*STP-209-1(2) Roadway and BHF-209-1(3) Bridge  
Widening of SR 74 From SR 85 to*

*P.I. Nos. 322355 and 322357*

**Value Engineering Study Report**

Preliminary Design Stage

DESCRIPTION: **ELIMINATE THE SIDWALK ADJACENT TO THE SOCCER** SHEET NO.: **1 of 6**  
**FIELDS**

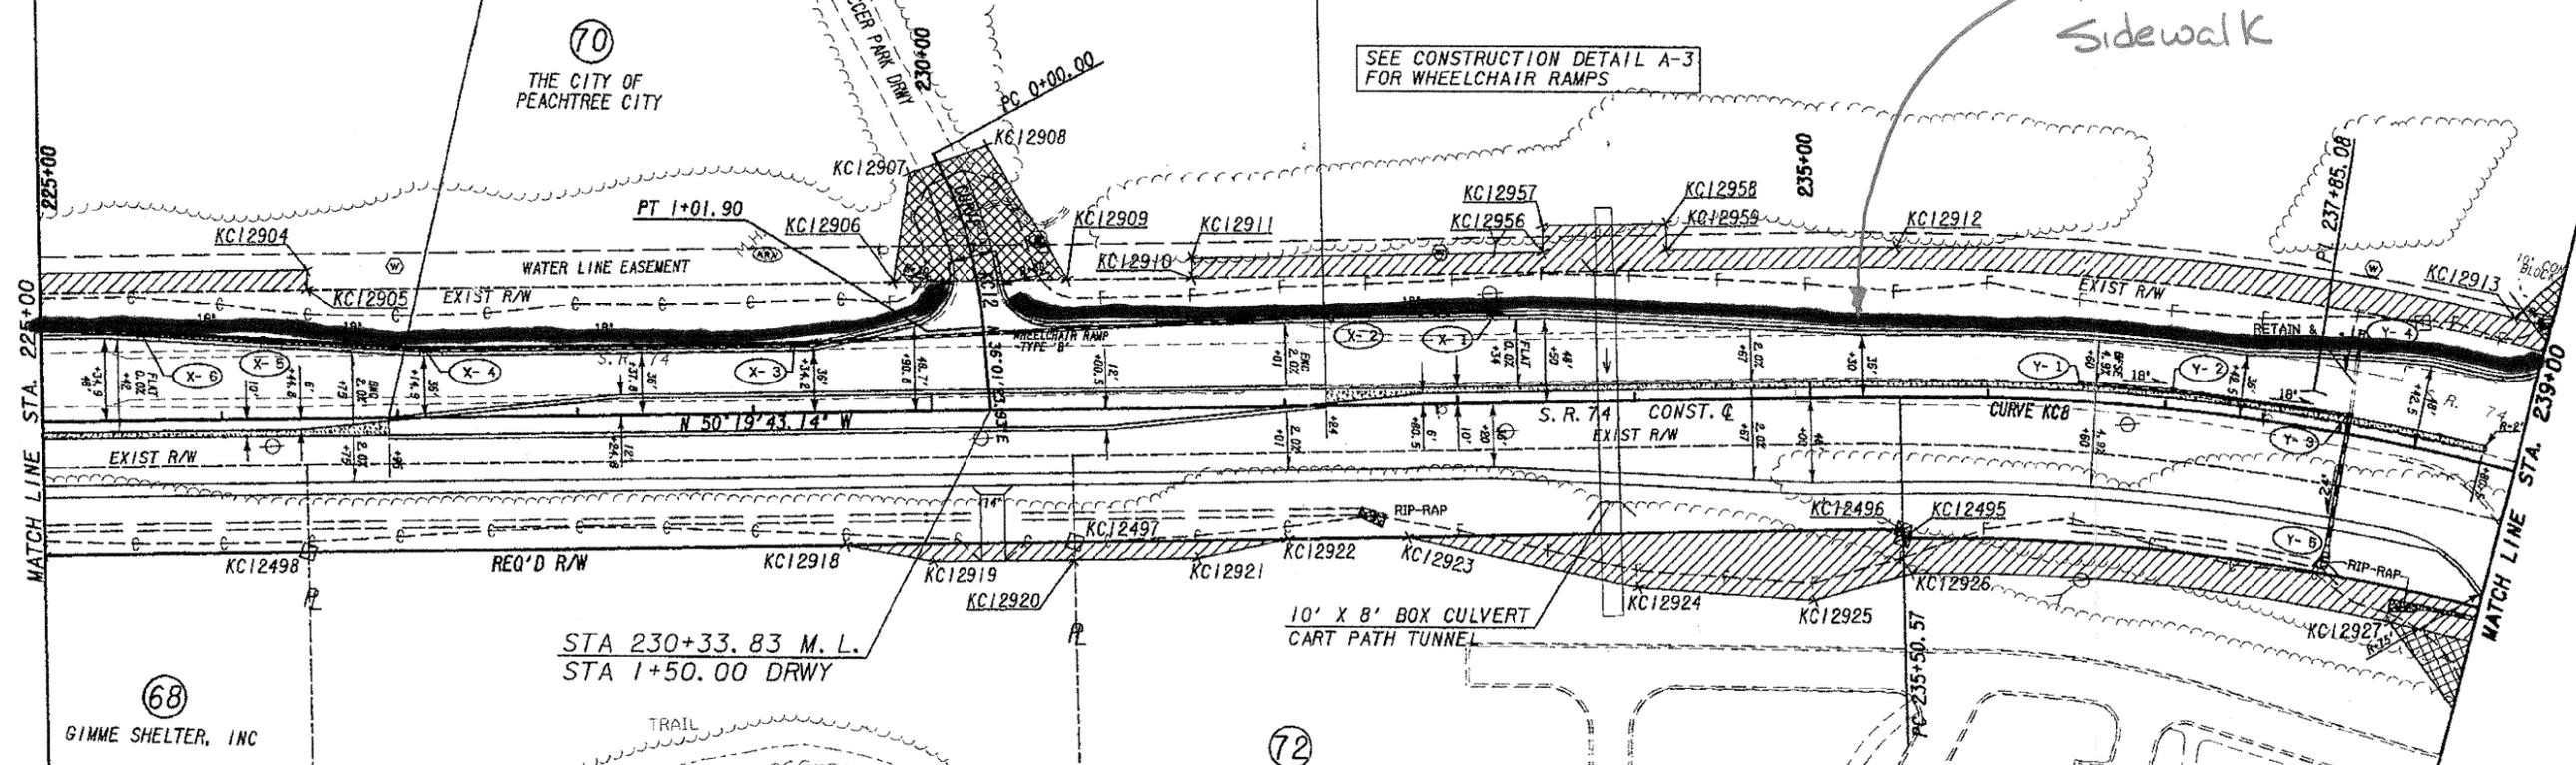
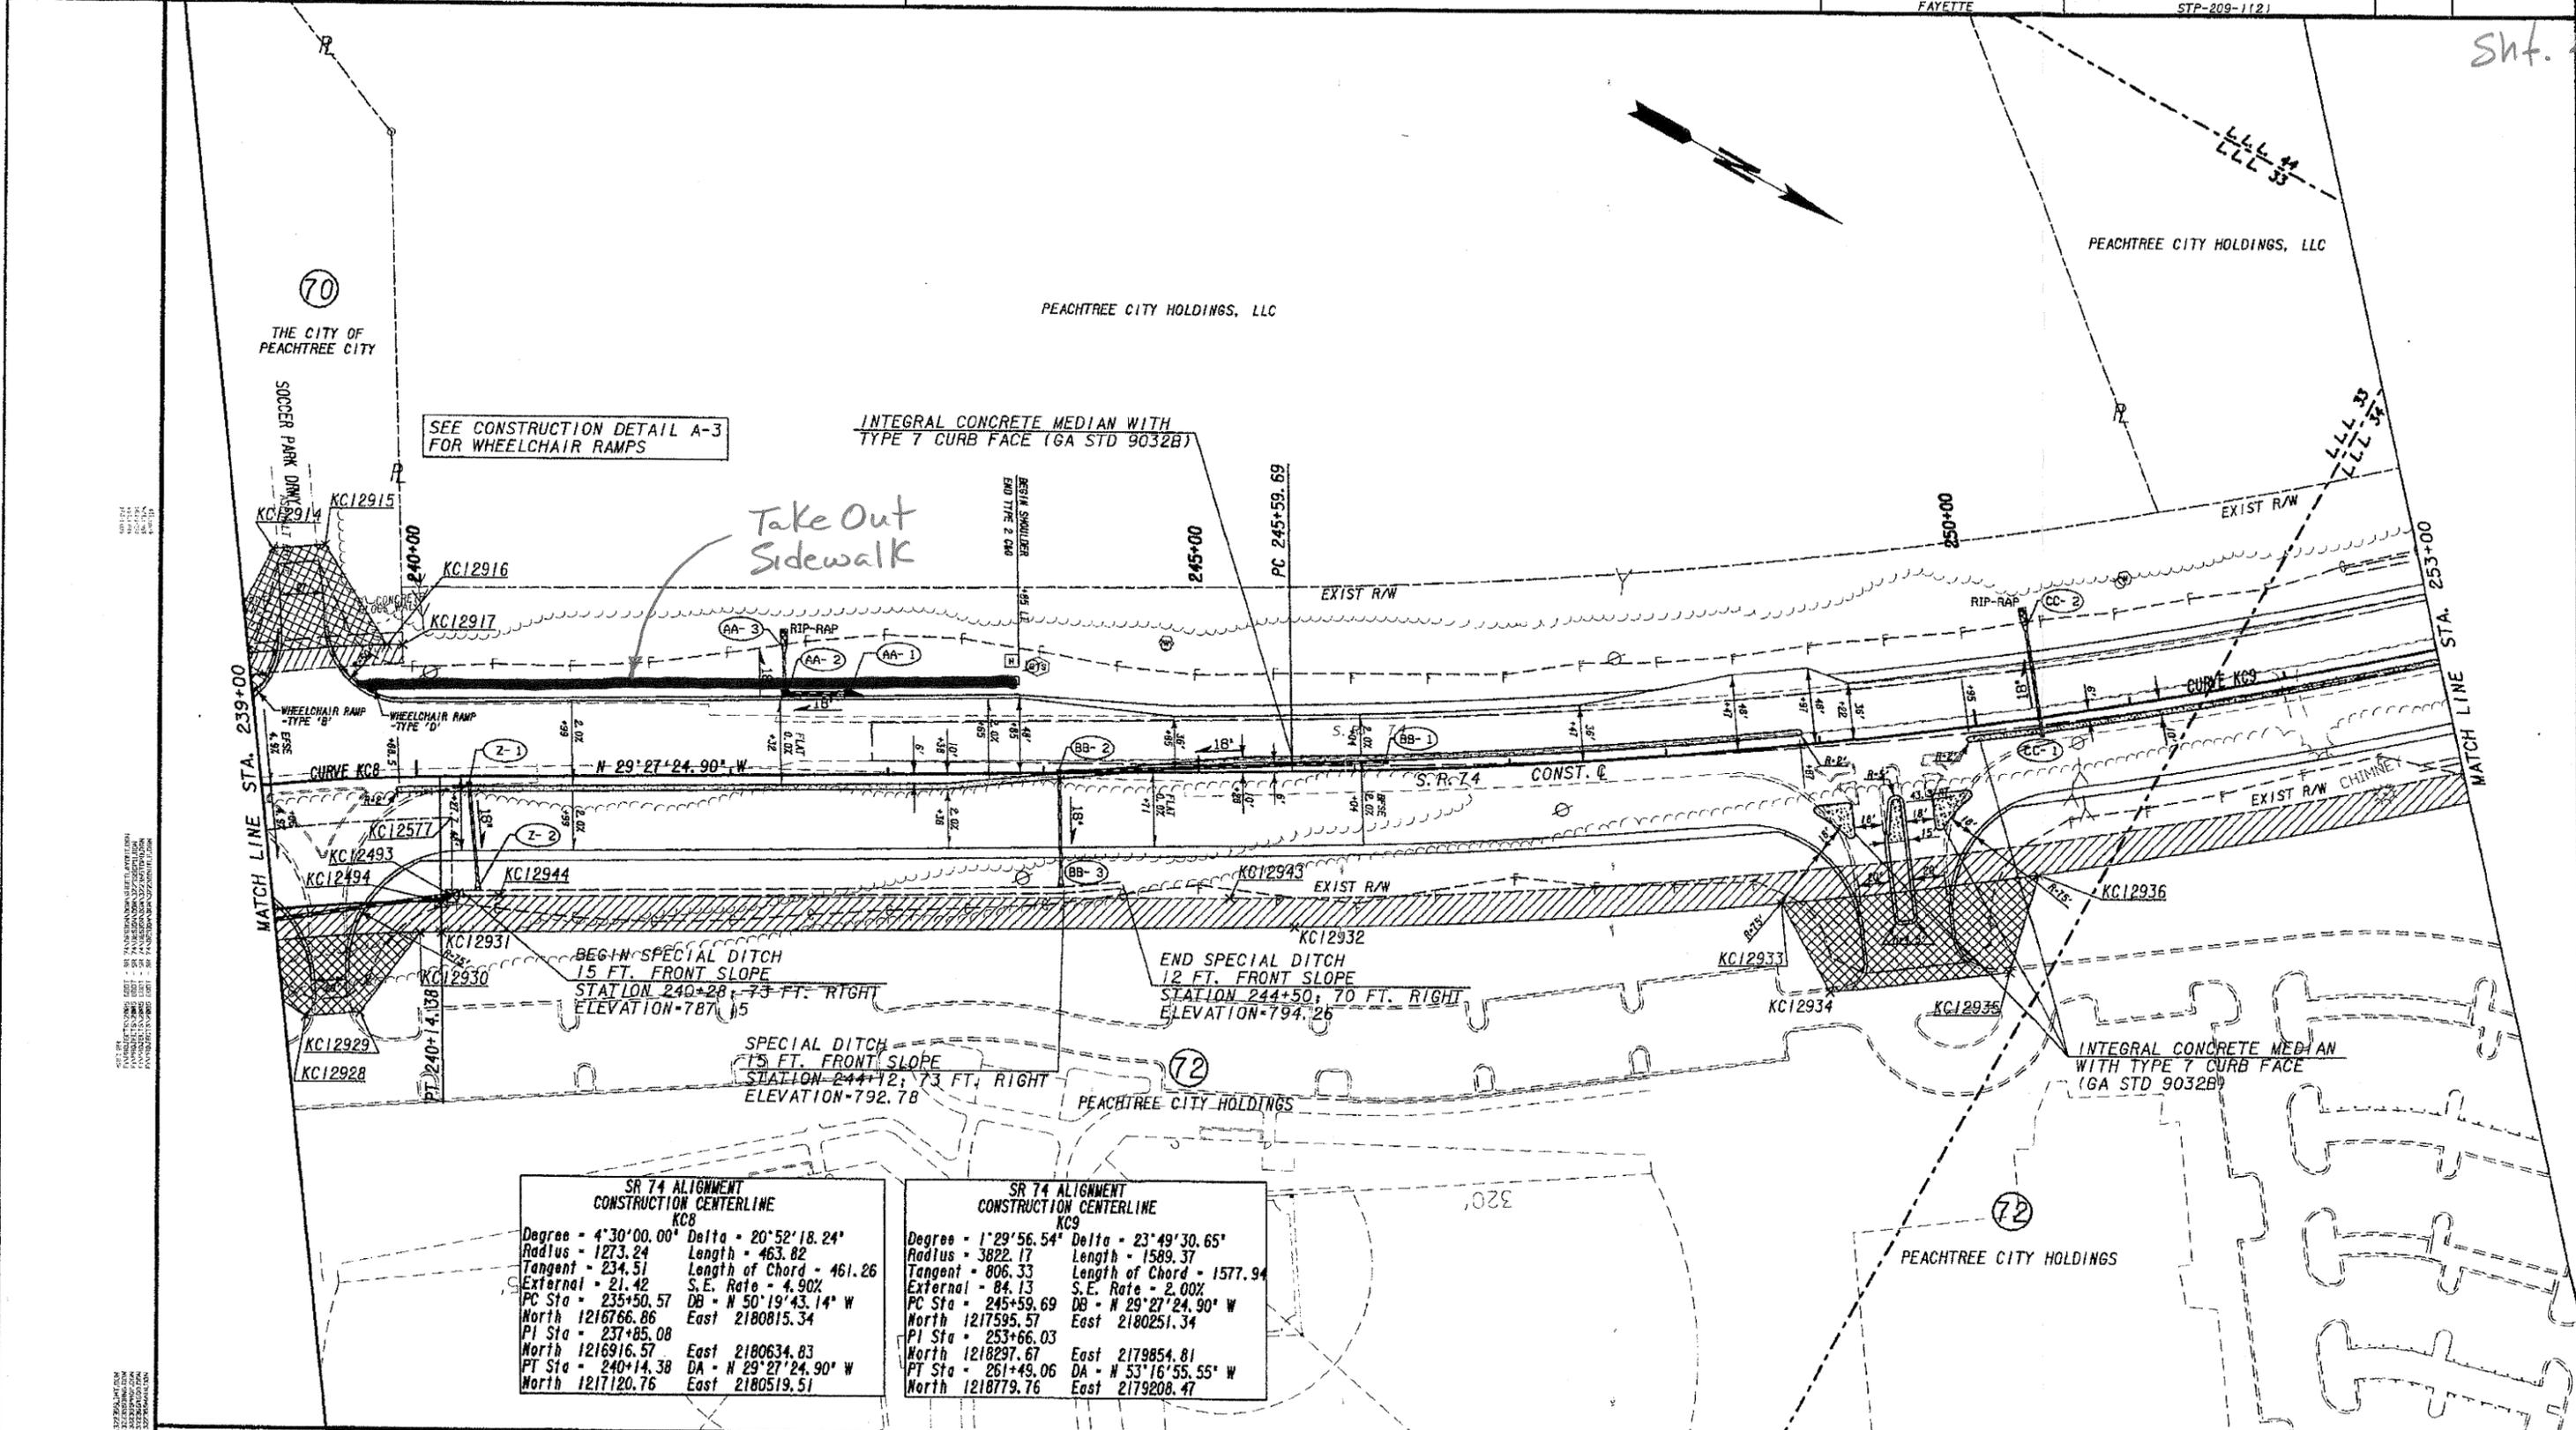
Curb and gutter and a sidewalk are provided on the south side of the road, the left side looking up to the Sta. starting at the Water Treatment Plant driveway and proceeding up to the Sta. past the soccer fields.

Eliminate the curb and gutter and sidewalk and add shoulder pavement in this area. Use earthen ditches along the south side of the road, drains under the driveways, and concrete flumes if necessary.
